March 15, 2018)

Cheryl Moon Siriani, District Executive Penn DOT, District #11, Thoms Run Road Bridgeville, Pa. 15017

To Cheryl Moon Siriani:

THE FOLLOWING FACTS SEEM TO SUGGEST A RE-CONSIDERATION OF CONSTRUCTING THE LEFT TURN STACKING LANE

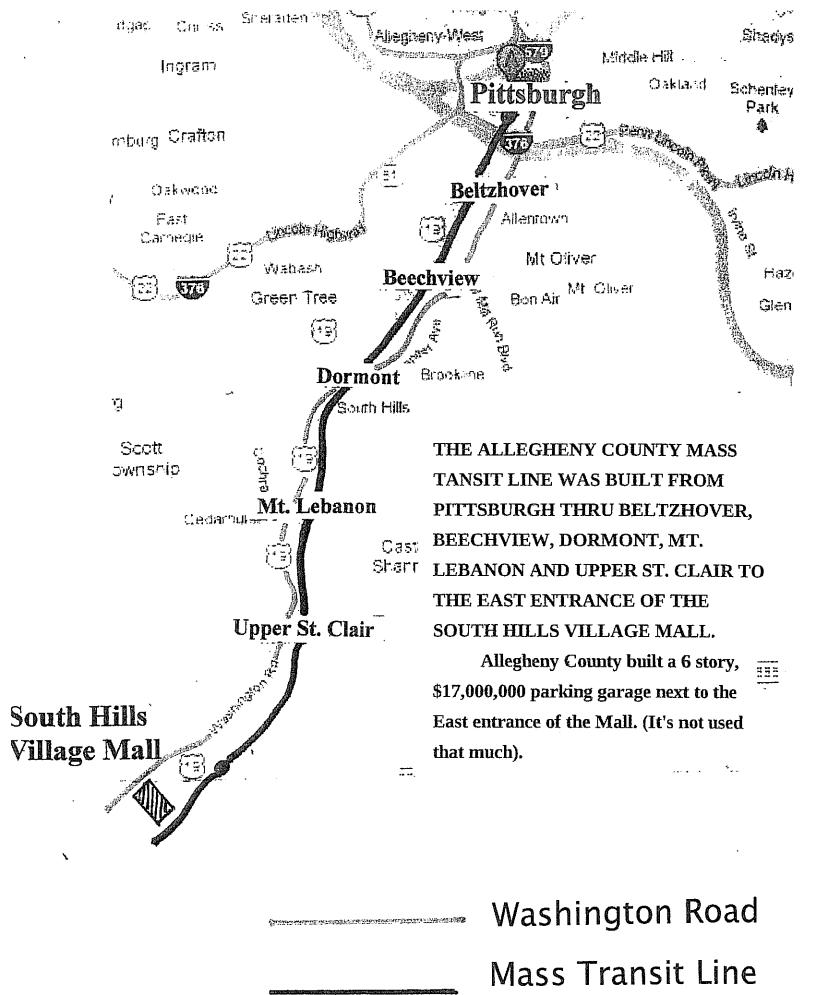
SHOWN IS HOW THE 4 LANE WIDENING OF BOWER HILL ROAD WAS NEVER CONTINUED TO THE *DORMONT* BUSINESS DISTRICT, NOR IN THE OPPOSITE DIRECTION TO THE *BRIDGEVILLE, COLLIER, SOUTH FAYETTE* BUSINESSS DISTRICT, IN ORDER TO LEAD CONSUMER MOTORISTS TO THE ROUTE #19 BUSINESS DISTRICT.

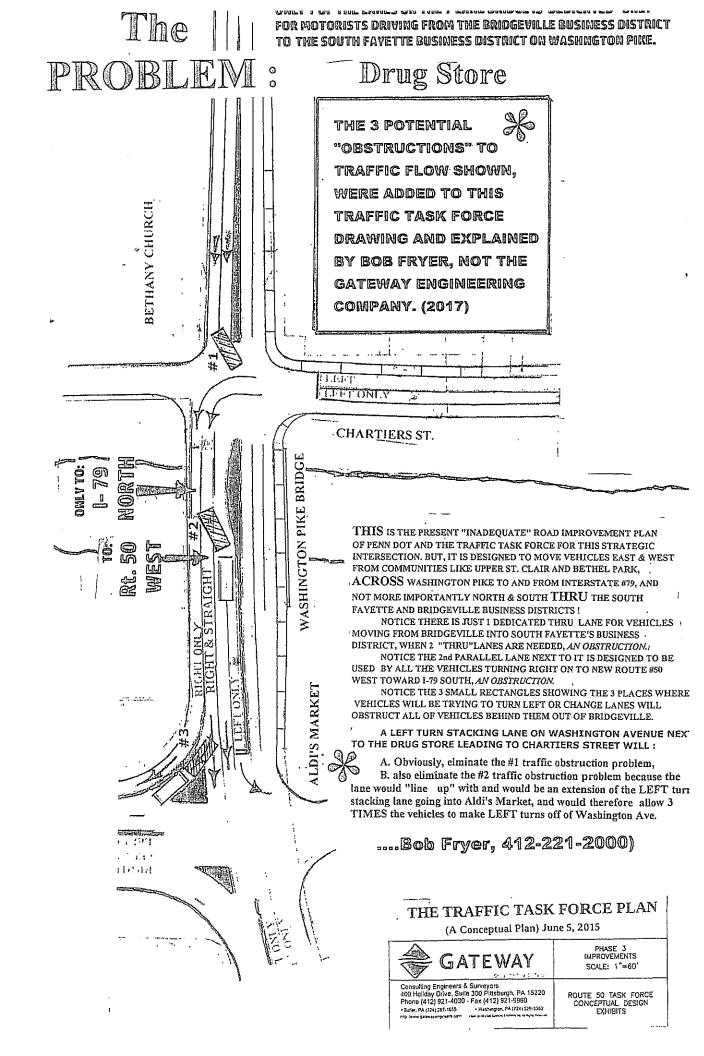
I would like to respectfully disagree, in that the **present distance** between the street and the store's parking lot is 36 FFET, and that the surface level of the parking lot is actually only 48 INCHES higher than the street.

ALSO, the **inside radius** of the present entrance and exit ramps is 20 feet, with a 10 foot long straight section to reach parking lot surface level.

By enlarging the inside radius of both ramps from 20 FEET to 36 FEET their lengths would be EXTENDED and their steepness would be decreased, making them easier for motorists to use than they are now. (Also, only 2 parking spaces would be sacrificed out of 72.) SEE DRAWING.

- 1. The new bridge will only have 1 Washington (Pike) Ave. lane dedicated exclusively for consumer-motorists from Bridgeville to enter South Fayette's central business district,
- 2. that there would be vehicles not able to "get completely into" the right lane on the bridge for vehicles moving to Route #50 West and I-79 South, that would block the 1 lane into the South Fayette central business district and
- 3. that there would be vehicles not able to "get completely into" the left turn stacking lane (on the bridge) leading to the Aldi Store shopping center, that would ALSO block the 1 lane into the South Fayette central business district from Bridgeville. SEE DRAWING.

SHOWN BELOW IS THE PROPOSED NEW POSITION OF THE INSIDE EDGE OF THE WASHINGTON AVENUE SIDEWALK, THAT IS NECESSARY FOR THE "LEFT TURN STACKING LANE" TO BE BUILT.

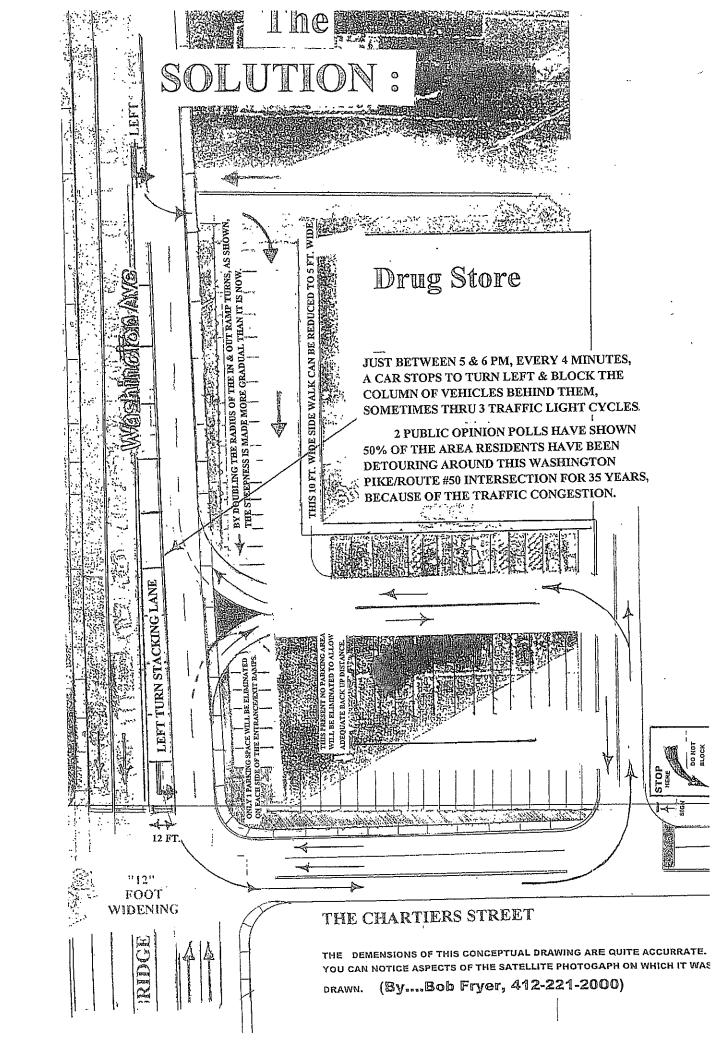
We defined the "new necessary position" of the inside edge of the new Washington Avenue sidewalk closest to the store as... a "tapered" straight line, from its widest 10 FOOT width closest to the Chartiers Street corner, decreasing to "0" FEET in width as it continued 450 feet further North, to the corner of James Street, across from the U.S. Post Office.

Therefore, the amount of property needed becomes less and less as the new sidewalk continues to the North. SEE DRAWING.

THE DEMENSIONS OF THIS CONCEPTUAL DRAWING ARE QUITE ACCURRATE.
YOU CAN NOTICE ASPECTS OF THE SATELLITE PHOTOGAPH ON WHICH IT WAS

> SHOWN BELOW IS THE PROPOSED NEW POSITION OF THE INSIDE EDGE OF THE CHARTIERS STREET SIDEWALK, THAT IS NECESSARY FOR THE "ADDITIONAL" STACKING LANE TO BE BUILT.

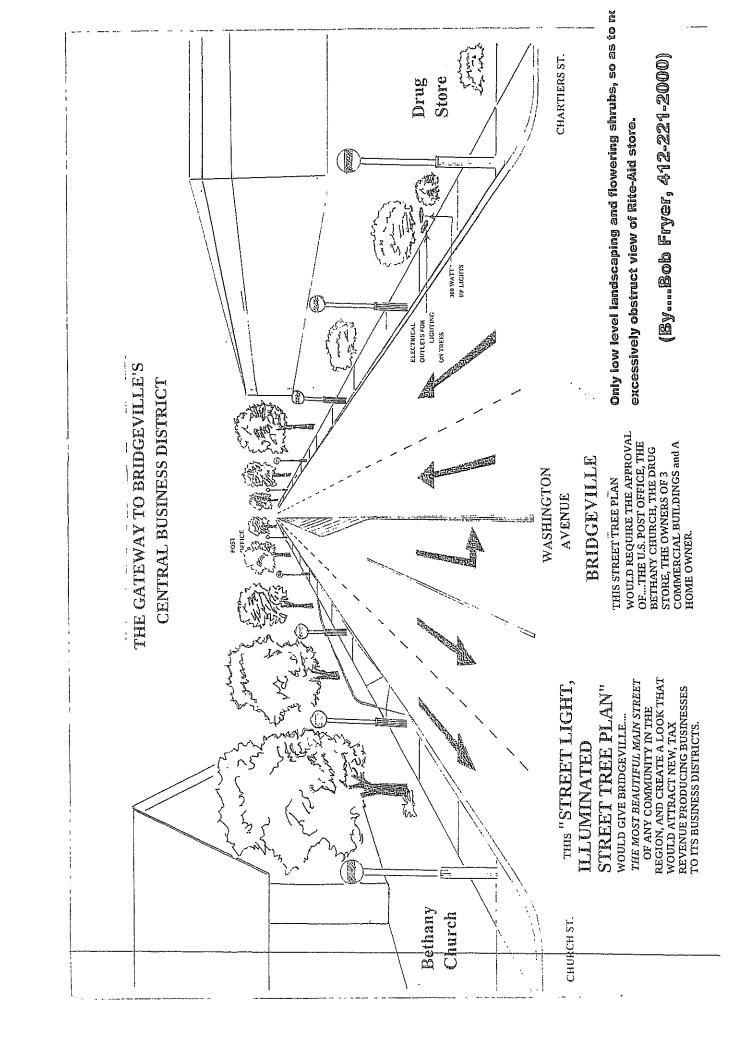
THE DEMENSIONS OF THIS CONCEPTUAL DRAWING ARE QUITE ACCURRATE. YOU CAN NOTICE ASPECTS OF THE SATELLITE PHOTOGAPH ON WHICH IT WAS

- 9. The 2 other property owners on Chartiers Street as well as the drug store owners, also seem agreeable to donate the land for the additional 12 foot wide, 150 yard long stacking lane there.
